# Fire Damper Testing Report

CERTIFICATE OF DAMPER INSPECTION AND TESTING IN ACCORDANCE WITH BS 9999

Certificate:	<b>SO-369168</b>	Inspection Date:	<b>05/12/2024</b>
--------------	------------------	------------------	-------------------

Building:	<b>60 Great Tower Street BD00196</b>
Address:	<b>London, EC3R 5AZ, United Kingdom</b>

<b>Building:</b>	<b>60 Great Tower Street BD00196</b>		<b>QR Image</b>	
<b>Asset No:</b>	<b>A20360</b>

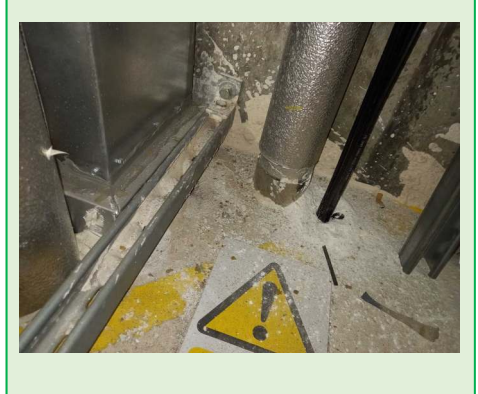
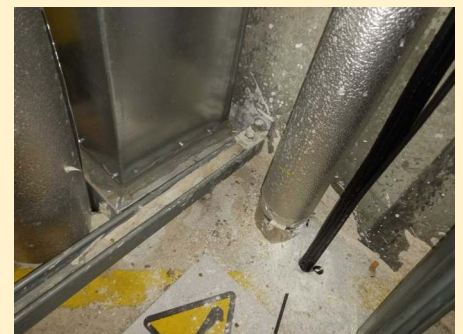
<b>Installation:</b>	Defect - Installation clearly deviates from manufacturer installation details and/or best of practice guidance - Inadequate supports, and/or incorrect damper frame to support and integrate with the fire barrier compound
----------------------	---

Damper not responding to drop test upon the release of the fusible link or thermal release switch.

Fusible link damaged by tek screw unable to release

Minimum clearance between fire damper cases installed in separate ducts is 200mm [unless tested otherwise], and 75mm between the damper and an adjacent wall or floor [refer to BS EN 1366-2:2015 sections 7.3 and 13.6]

Inadequate support(s) and/or not correctly integrated with the compartment system [refer to BS 9999:2017 - 32.5.2.5]

Screw [tek] fixings have been used to connect the ducting to the damper. Fixings need to be changed to a fire-resistant material with a low melting point such as aluminum or plastic to act as a breakaway joint [refer to BS 9999:2017 - 32.5.2.5]

Damper in poor position too close to wall and adjacent service pipe and no HEVAC frame to integrate into mortar fire break... tek screws used for damper duct connection

<b>Building:</b>	60 Great Tower Street BD00196		<b>QR Image</b>	
<b>Asset No:</b>	A20366

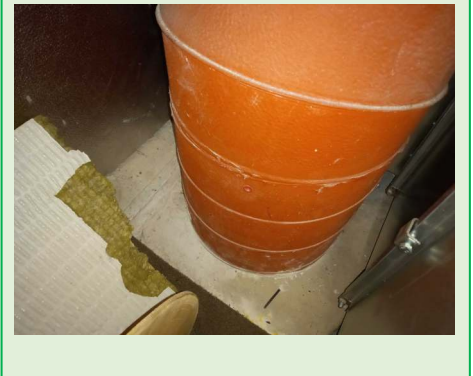
<b>Access Panel:</b>	Defect: no access panel installed		
<b>Shape:</b>	N/A	<b>Size:</b>	N/A
<b>Accessibility [Both Sides]:</b>	No

To enable the damper to be tested, inspected, and reset access panels need to be installed. Access panels shall be quick release insulated sealed panels, manufactured, and installed to BESA specification DW144 [BESA DW 144 - Section 20 Access/Inspection openings].

No access panel installed... New 400x200 access panel required

<b>Building:</b>	60 Great Tower Street BD00196		<b>QR Image</b>	
<b>Asset No:</b>	A20356

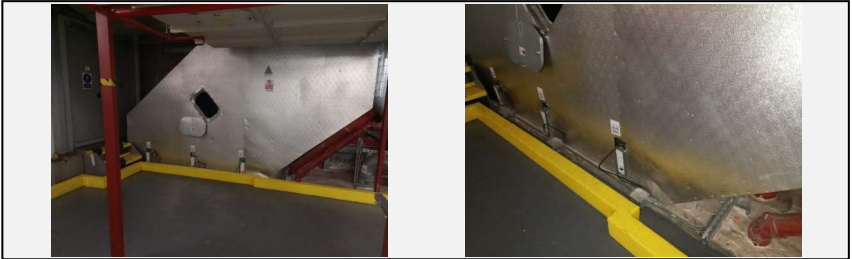
No access panel installed on plantroom side with damper blade handle... very limited duct space for new access panel... New 150x150 access panel required with 250 saddle

Inadequate support(s) and/or not correctly integrated with the compartment system [refer to BS 9999:2017 - 32.5.2.5]

Mounting plate needs to be fixed to mortar fire break

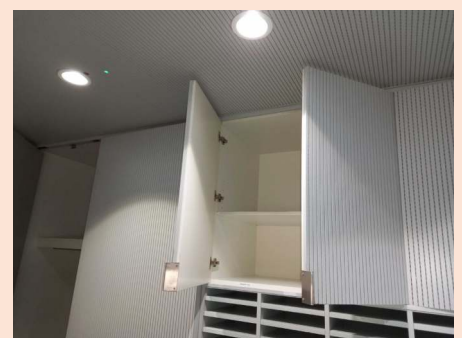
**Ceiling hatch required [No access arrangements]**  
 Inadequate means of access has be provided to allow inspection, testing and maintenance of both the fire damper and its actuating mechanism. Actions required to provide suitable accessibility [BS 9999:2017 - 32.5.2.5]

**Services obstructing access [No access arrangements]**  
 Inadequate means of access has be provided to allow inspection, testing and maintenance of both the fire damper and its actuating mechanism. Actions required to provide suitable accessibility [BS 9999:2017 - 32.5.2.5]

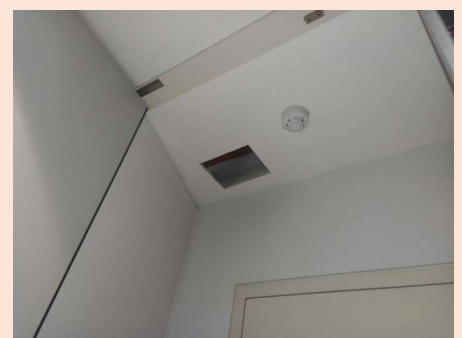
**Ceiling hatch required [No access arrangements]**  
 Inadequate means of access has be provided to allow inspection, testing and maintenance of both the fire damper and its actuating mechanism. Actions required to provide suitable accessibility [BS 9999:2017 - 32.5.2.5]

**Services obstructing access [No access arrangements]**  
 Inadequate means of access has be provided to allow inspection, testing and maintenance of both the fire damper and its actuating mechanism. Actions required to provide suitable accessibility [BS 9999:2017 - 32.5.2.5]
